E	12/03/12	Section 75W Submission	PL	MD
D	04/11/11	Revised Design following SOPA comments	JC	MD
B	09/09/11	Revised Design following SOPA comments	MD	MD
A	06/04/11	DA Submission	JL	MD
Revision	Date	Description	Initial	Checked

Site 3
Sydney Olympic Park
Plan
Basement 001

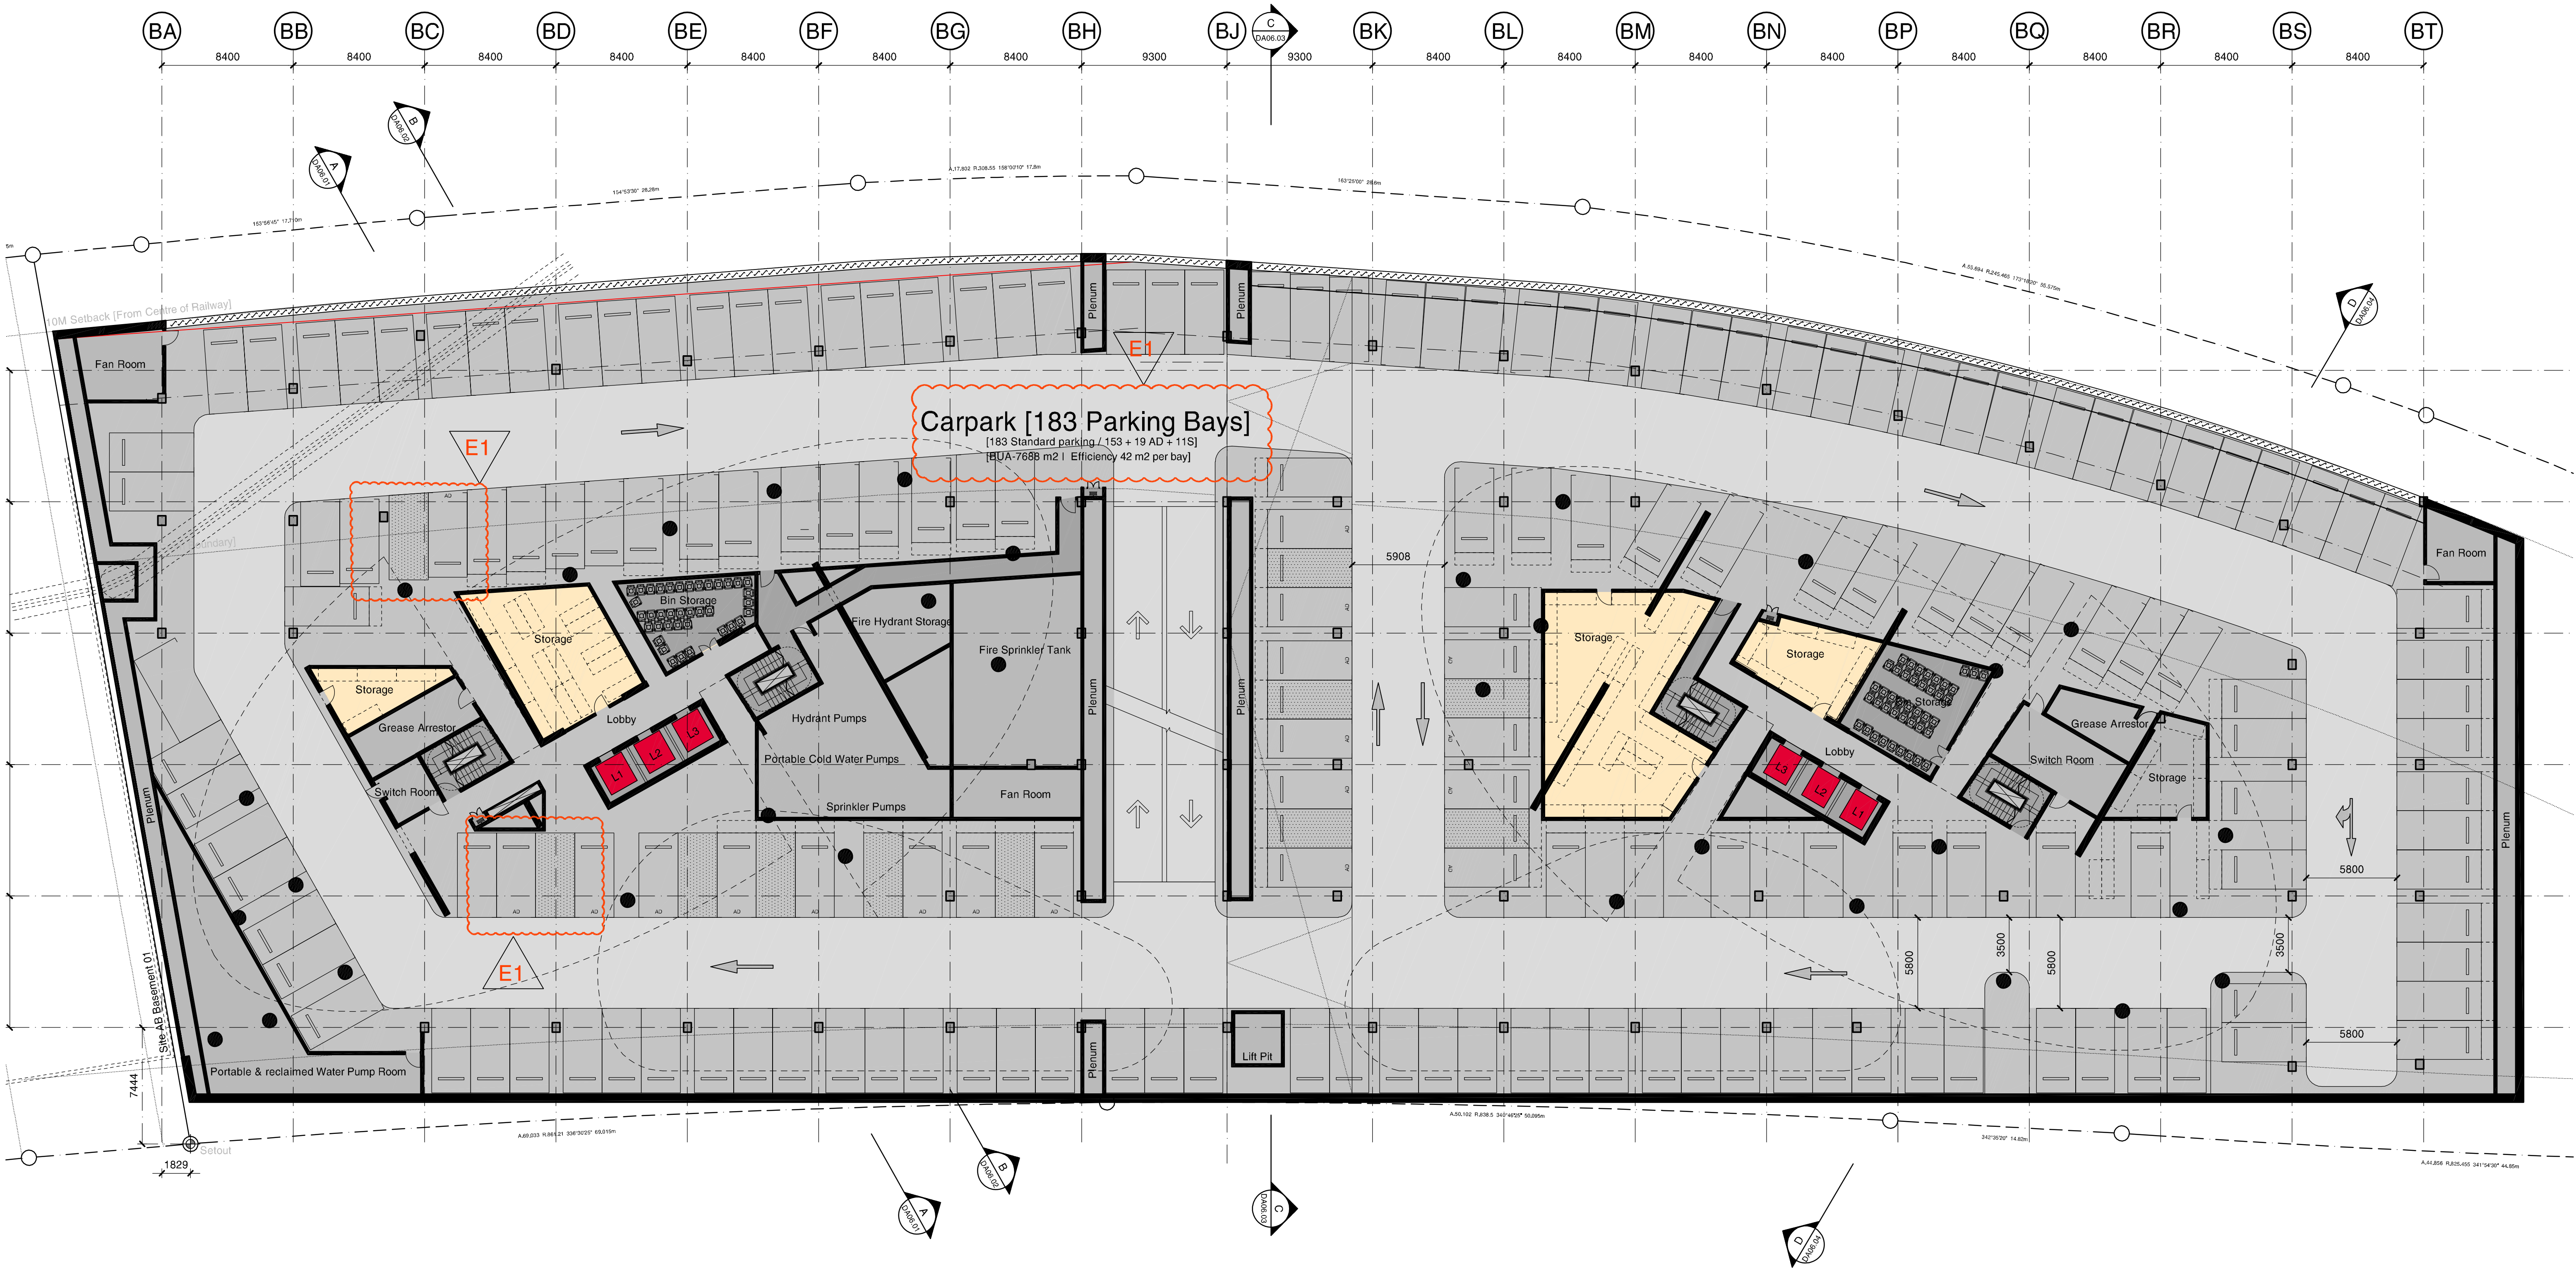
Revision E - Section 75W Amendments.
1 Four spaces have been converted to two disabled spaces to accommodate increase in total adaptable apartments numbers (additional 2, from 59 to 61)

Site 3
Sydney Olympic Park
Plan
Level 12

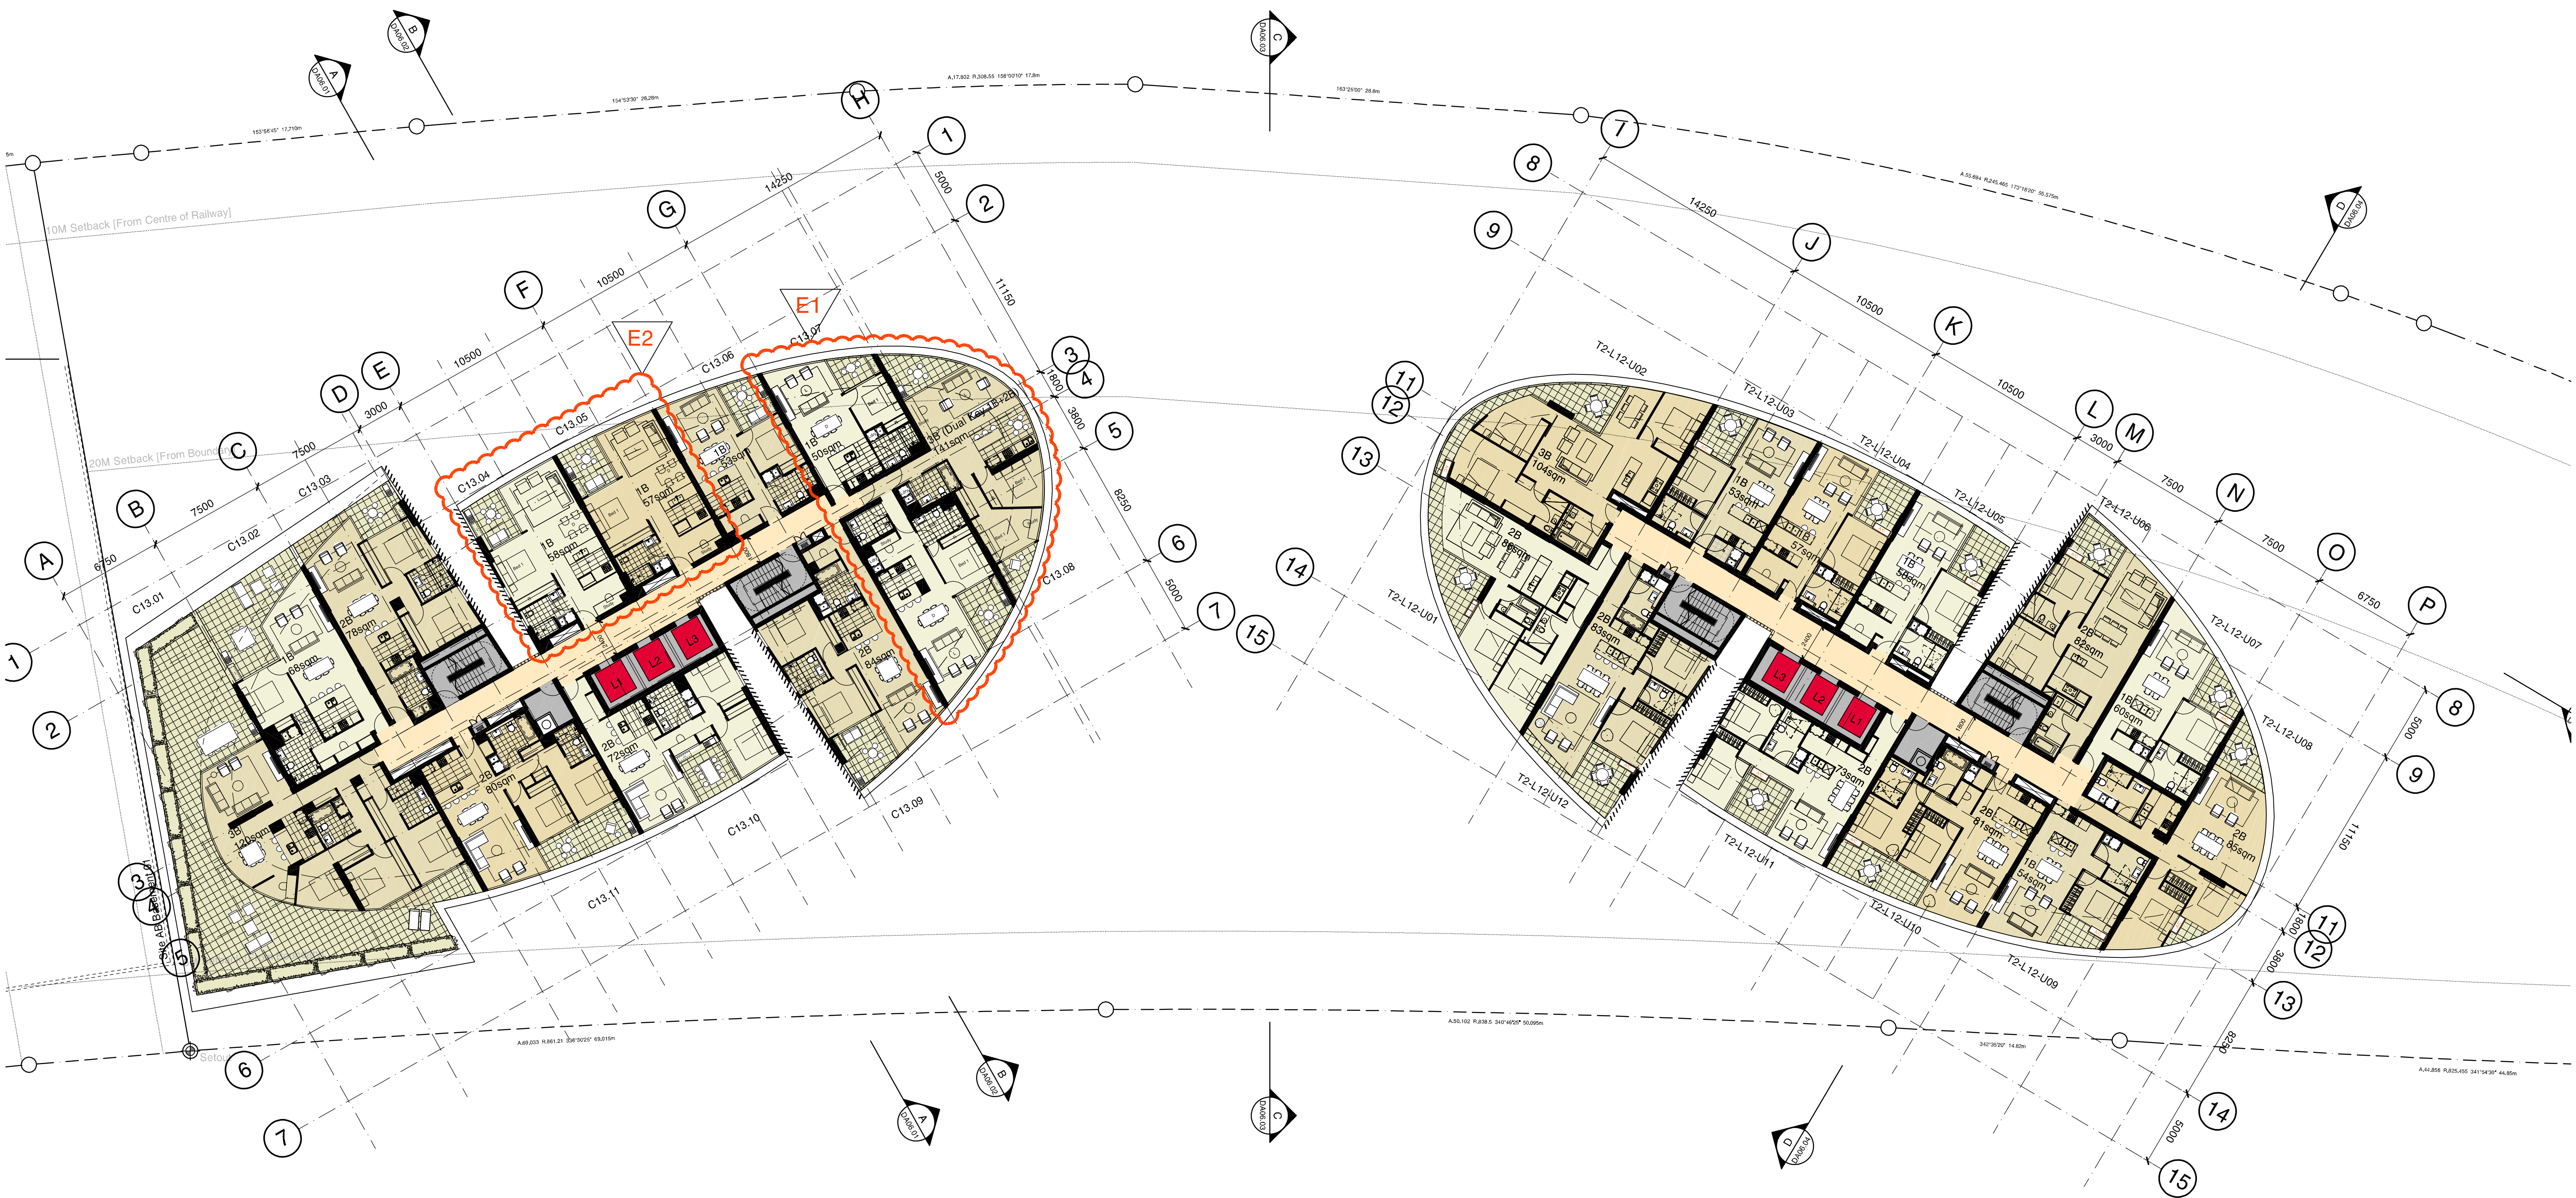
1. Change of apartment mix from one 3-Bed and one 2-Bed (C13.07 & C13.08) to one 1-Bed and one 3-Bed Dual Key (1-Bed+2-Bed) (C13.07 & C13.08).

2. Apartments C13.04 & C13.05 have been allocated as adaptable units.

Site 3
Sydney Olympic Park
Plan
Level 13-18

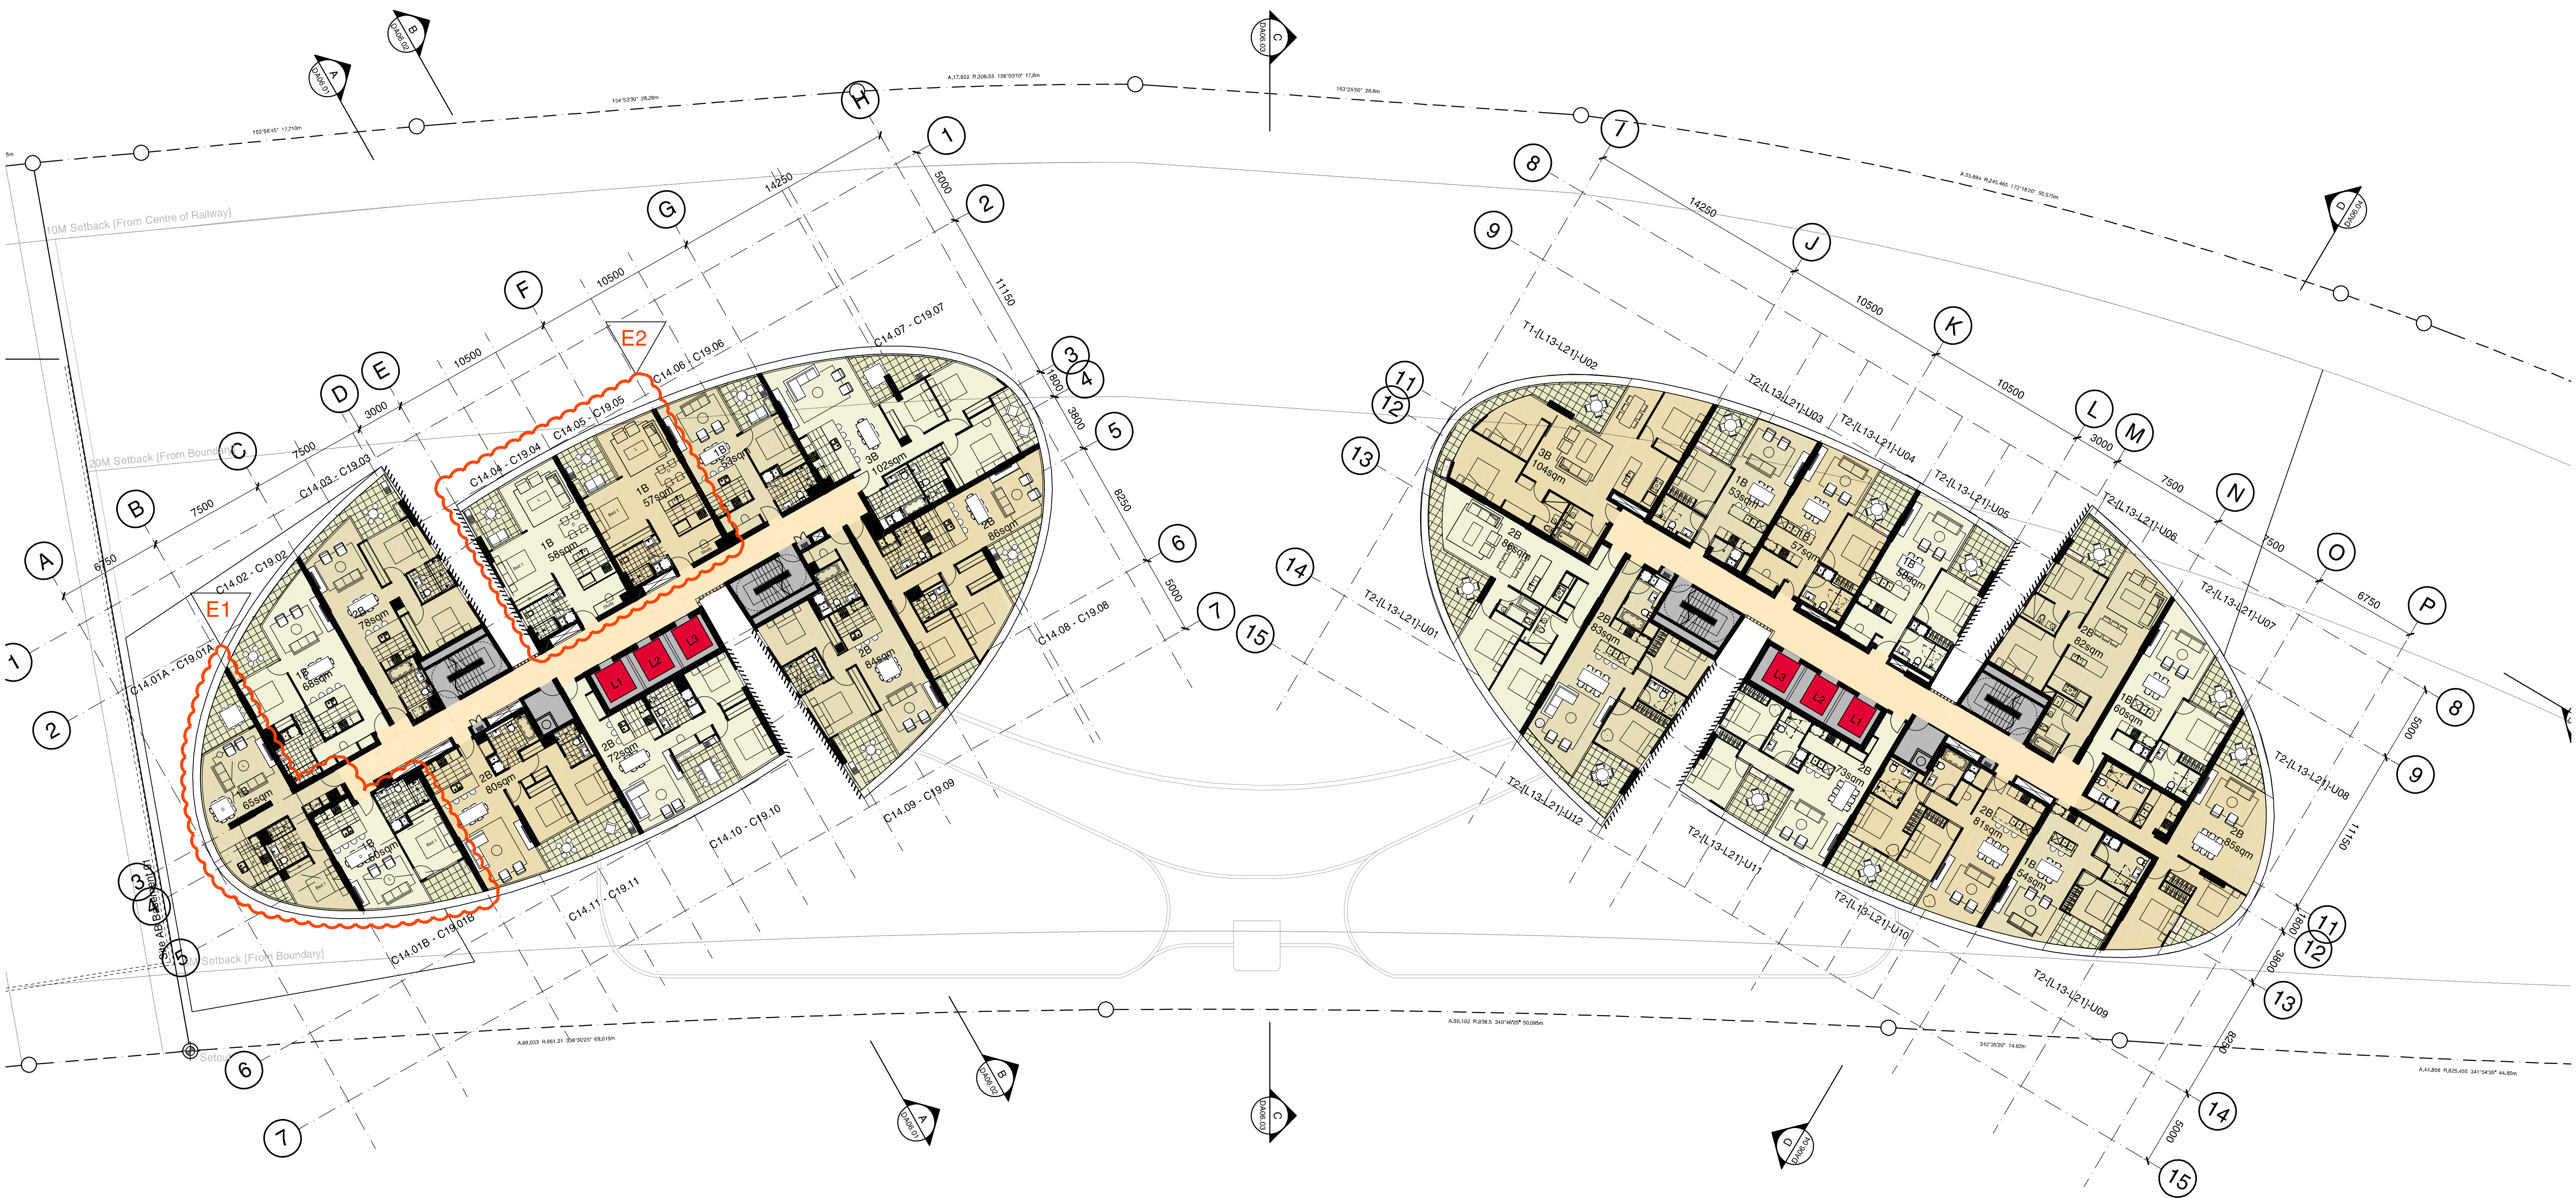
1. Change of apartment mix from one 3-Bed (C14.01-C22.01) to two 1-Bed (C14.01A-C22.01A & C14.01B-C22.01B).

2. Apartments C14.04-C22.04 & C14.05-C22.05 have been allocated as adaptable units.
